BULLETIN No BE-037/89 "JANTAR-ST"

Ref: Possible lite-time extension above 3000 flying hours
for the gliders of: SZD-41A, SZD-48 and SZD-48-1 type.

PROCEDURES FOR WING SPAR ROOT PIN REPLACEMENT ON SZD-41A,
SZD-48 AND SZD-48-1 GLIDERS.

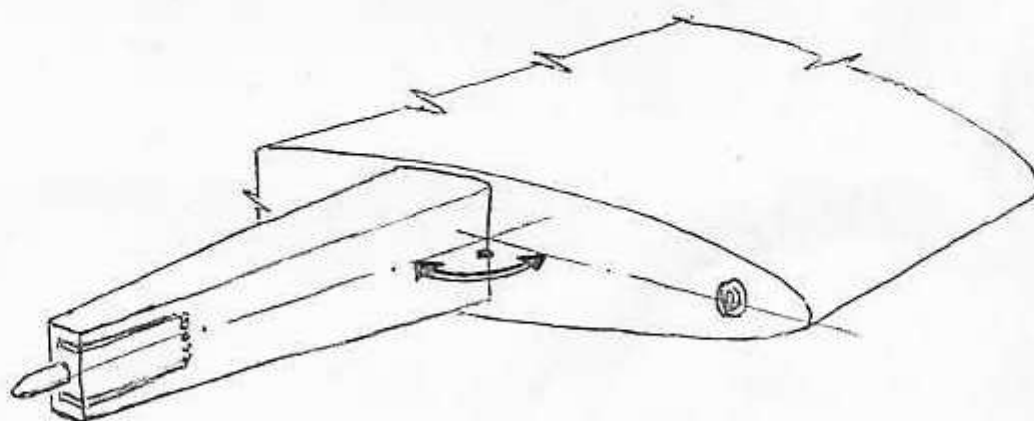
- 1.1. Remove the fabrics item 27 and 23 and roving wrap item 15 (items acc.to drawing No 11-90-00 and 11-91-00, sheets 1 and 2) out of the spar roots. Smooth and clean the opened surfaces.

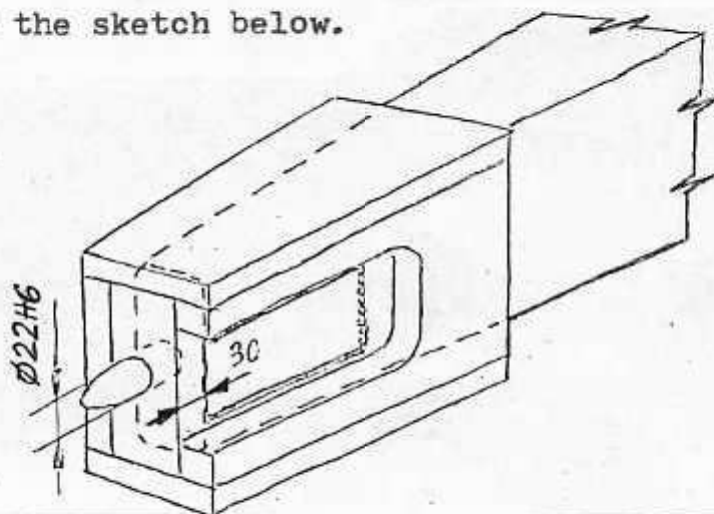
- 1.2. Mark the outline of the opening for duraluminium "block" with the pin on the external wall side (perpendicular to the root rib plane). Dimensions of the opening: length 160 mm (measured from the spar root), width 40 mm (symmetrical in respect to the pin axis).
- 1.3. According to the marking make the proper longitudinal cut and drills (avoid the damage of the opposite spar wall "oblique" in respect to the rib and spar longerons plane).

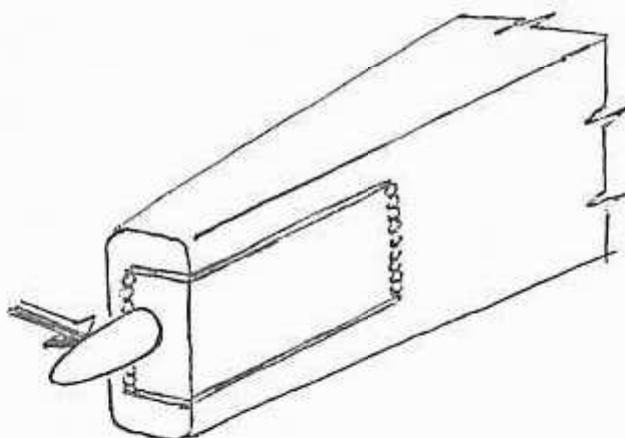
- 1.4. Preserve the "old" pin situation in respect to the spar root geometry by means of 11-90-00/Px4 tool or the auxiliary tool of wood or plywood as shown on the sketch below.

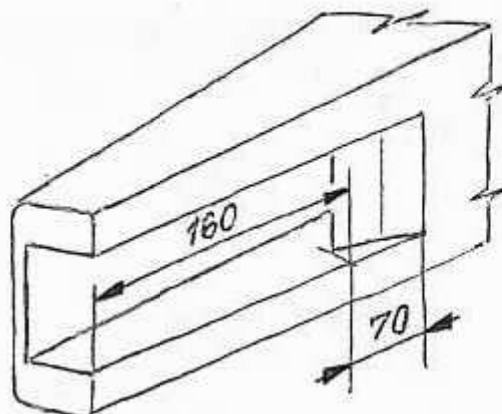
- 1.5. Sperate the pin out of the "oblique" spar wall by means of drilling with the long drill paralely to the pin axis (in case the auxiliary tool is used it should be removed out of the spar). Remove the "old" pin tearing it out of the wall.

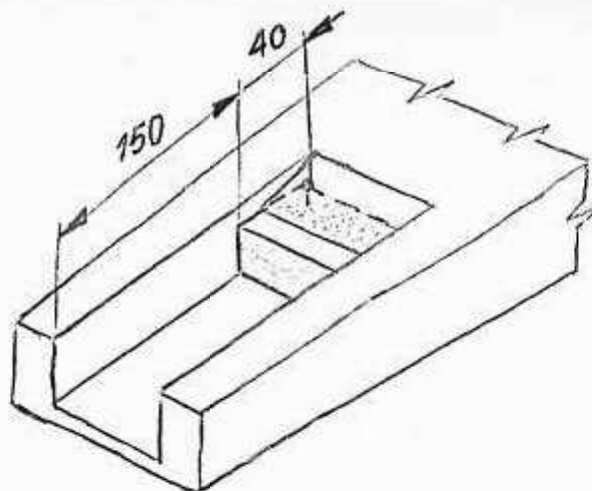
- 2.2. Prepare the block of CC45 foam of 40 mm thickness which after fitting should be glued on composition*) with Aerosil in the distance of 150 mm from the spar root (the foam block is aimed to close the space into the spar inside to avoid the composition flow-out when the aluminium "block" with pin is glued in). Close the opening in the pin with the plug of CC45 foam.

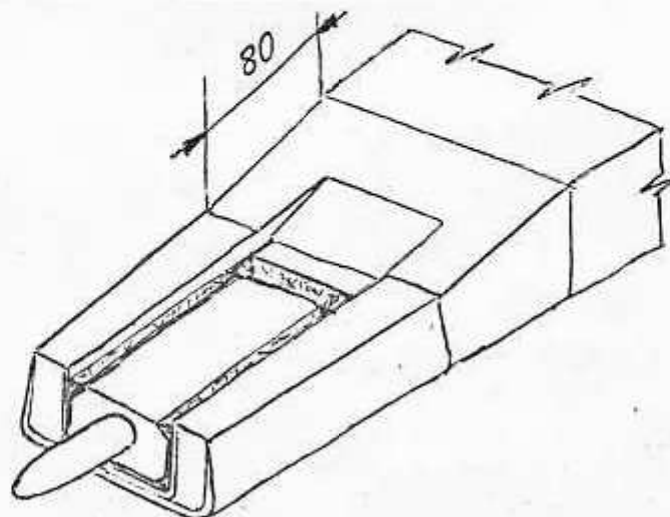
- 3.1. Cover the cavity walls with the layer of Ep 52+ Z1 composition + 40 per cent of cut glass roving + 3 per cent of Aerosil, taking into account the plays between the "block" and cavity walls. Basing the pin with "block" acc. to the tool press it so that the composition excess could flow off. The slots and the space between the duraluminium "block" and foam block should be filled with the above mentioned composition with the cut roving up to the "block" surface plane.

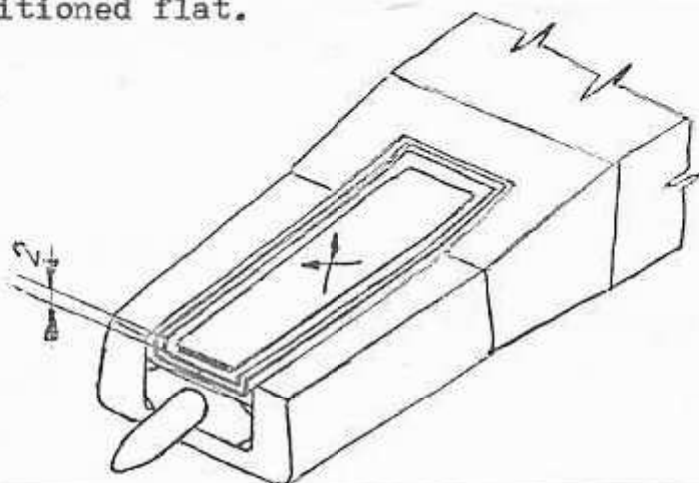
- 4.2. Glue in (with the composition as given on page 3*) the compensating fabrics 92110 ✕ on the cavity above the "block" in such a way that when positioned on the "block" and short chamfer between the longerons they have a "C-section" shape with the legs connected to the spar longerons.

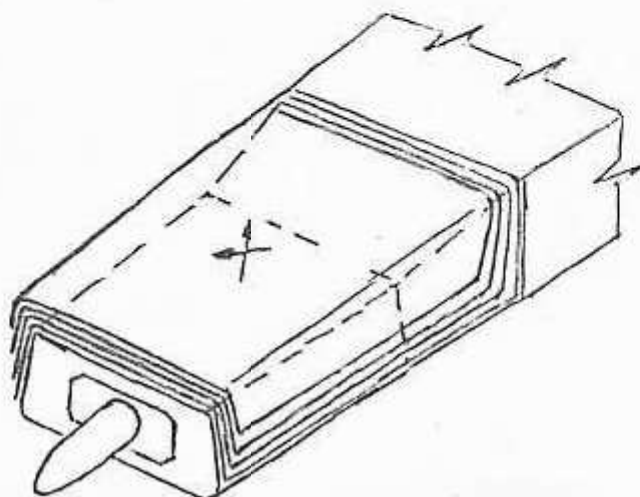
When the "C-section" legs get 2 mm width the last compensating (to longeron edges) fabrics should be positioned flat.

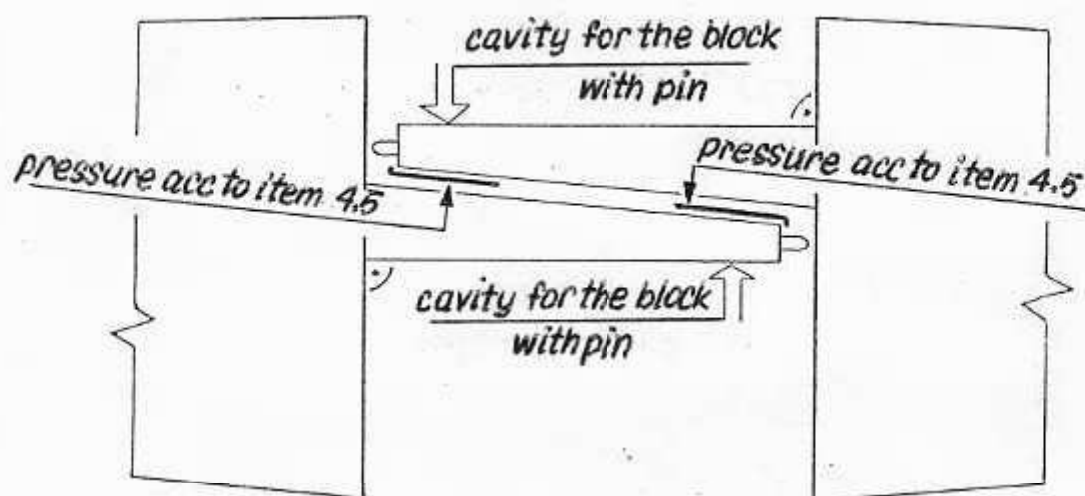
- 4.3. After curing the compensating fabrics the whole set should be cleaned and prepared for glueing in the fabrics for rebuilding the wall.
- 4.4. Rebuild the wall by means of glueing in 15 layers of 92110 ✕ fabrics. Place the fabrics stepping the overlaps in respect to the "chamfers" on length and width as well. The eventual identations on the root should be filled using the composition with cut fibres.
